Product Change Notice (PCN)

Subject: Notice of change in 14x14mm LQFP Tape & reel Packing Components for RL78/G23
Publication Date: 3/25/2024
Effective Date: 7/1/2024

CHANGE TAPE & REEL PACKING for RL78/G23 14x14mm 80pin LQFP PRODUCTS DIFFERENCE DOCUMENT

Comparison of tape & reel material details: 14x14mm LQFP Tape & Reel packing

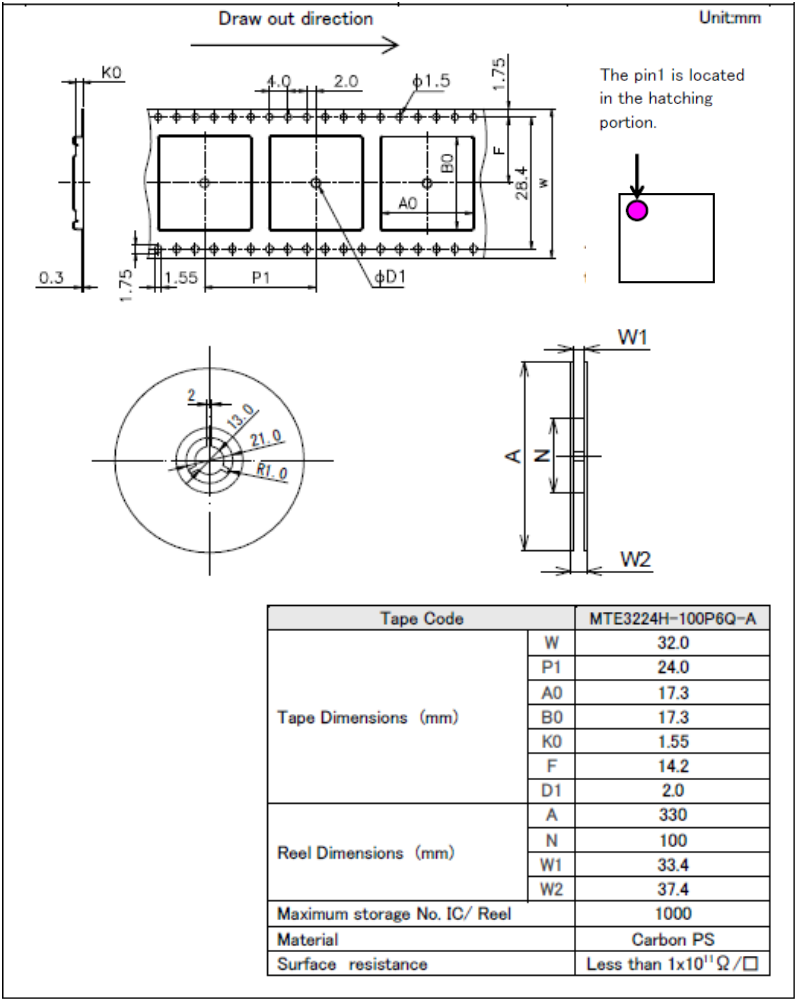
2. DIFFERENCE OF SPECIFICATION'S DETAIL (1)

| Packing material | Item | Before | After |
|------------------|---------------------------------|----------------------|------------------------------|
| Emboss tape | Taping code | MTE3224H-100P6Q-A | E2424Q14RA |
| | Sprocket hole | Both side | One side |
| | Tape width | 32mm | 24mm |
| | Cavity size | 17.3x17.3 | 16.5x16.5 |
| | Cavity depth | 1.55mm | 1.4mm |
| | Reel width | For 32-mm tape width | For 24 -mm tape width |

Comparison of tape & reel dimension: 14mm x14mm Tape & Reel LQFP Tape & Reel packing

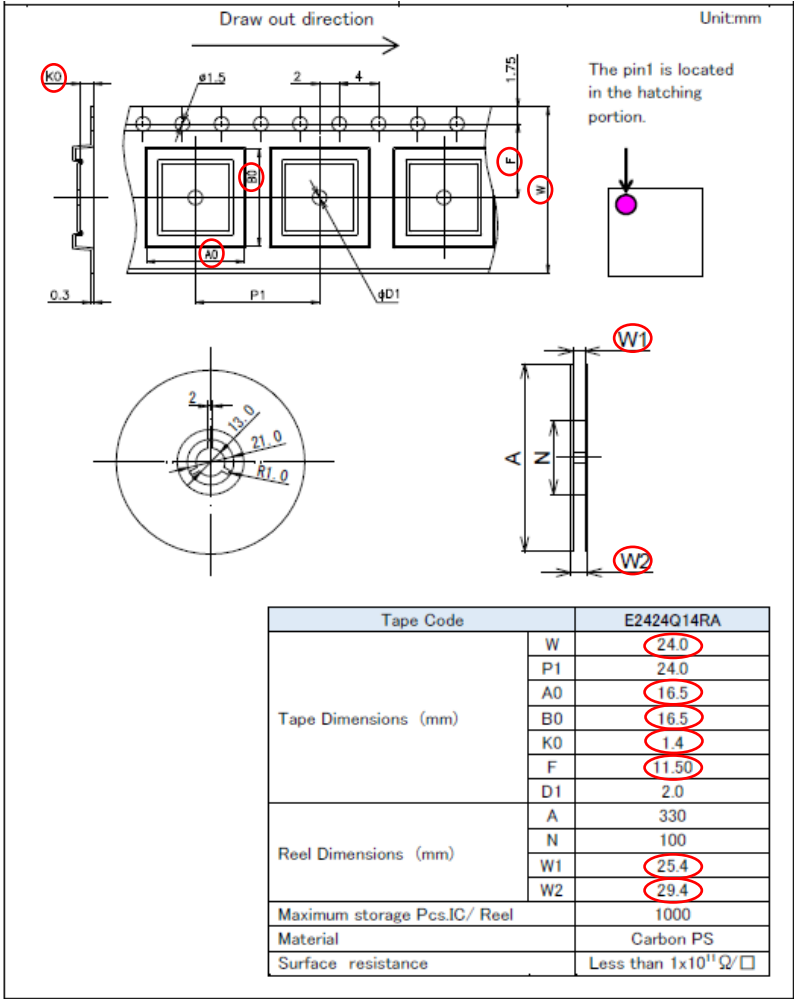
2. DIFFERENCE OF SPECIFICATION'S DETAIL (2)

Before (W:32mm)

After (W:24mm)
